Service Bulletin

Bulletin No.: PI1188

Subject: Duramax® Fuel Temperature Sensor Contacts Fuel Return Pipe After Pump Replacement

Models: 2012-2014 Chevrolet Silverado 2500/3500
2012-2014 GMC Sierra 2500/3500
Equipped with 6.6L Diesel Engine (RPO LML)

3629232

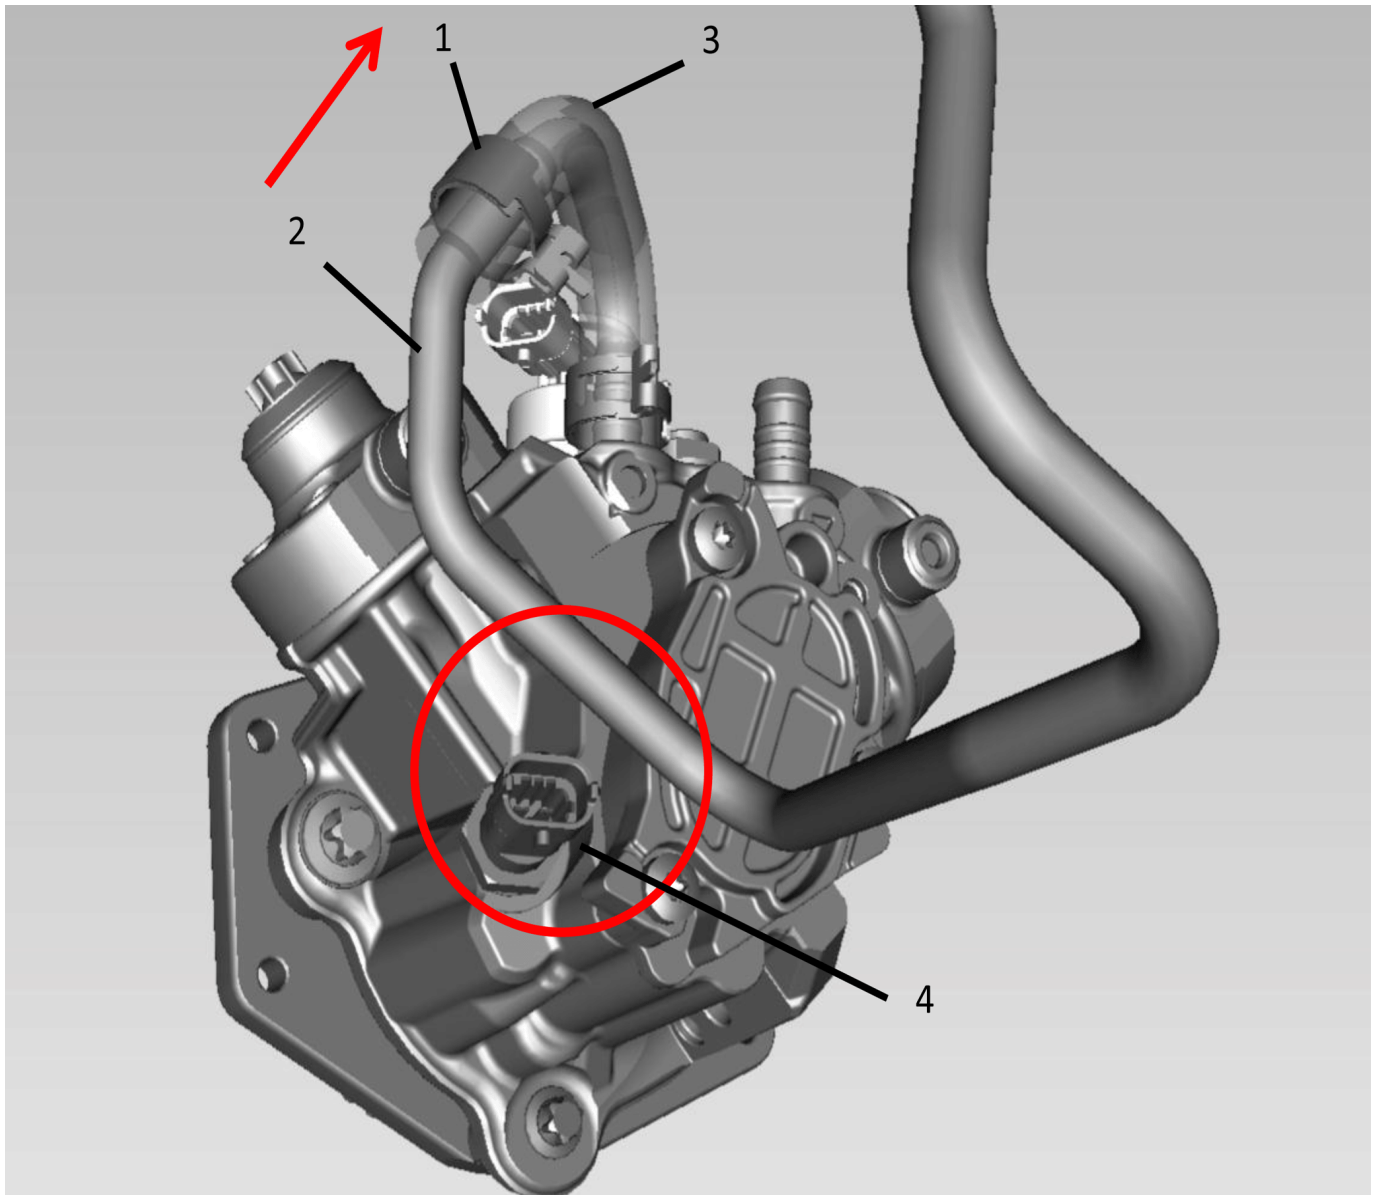
The following information may be helpful for a technician when replacing a fuel pump. If there is contact between the fuel temperature sensor connector and the fuel return line or clearance is very tight, please follow this service recommendation.

Follow the procedure below for inspecting the fuel return pipe to see if adjustment is needed. If sufficient clearance of 5 mm cannot be obtained through adjustment, replace the fuel return pipe with the newer design.

1. Remove the fuel return pipe to fuel return hose clamp (1).
2. Adjust the fuel return pipe (2) deeper into the fuel return hose (3).
3. Rotate the pipe assembly away from the fuel temperature sensor (4).
4. Install the fuel return hose clamp (1).
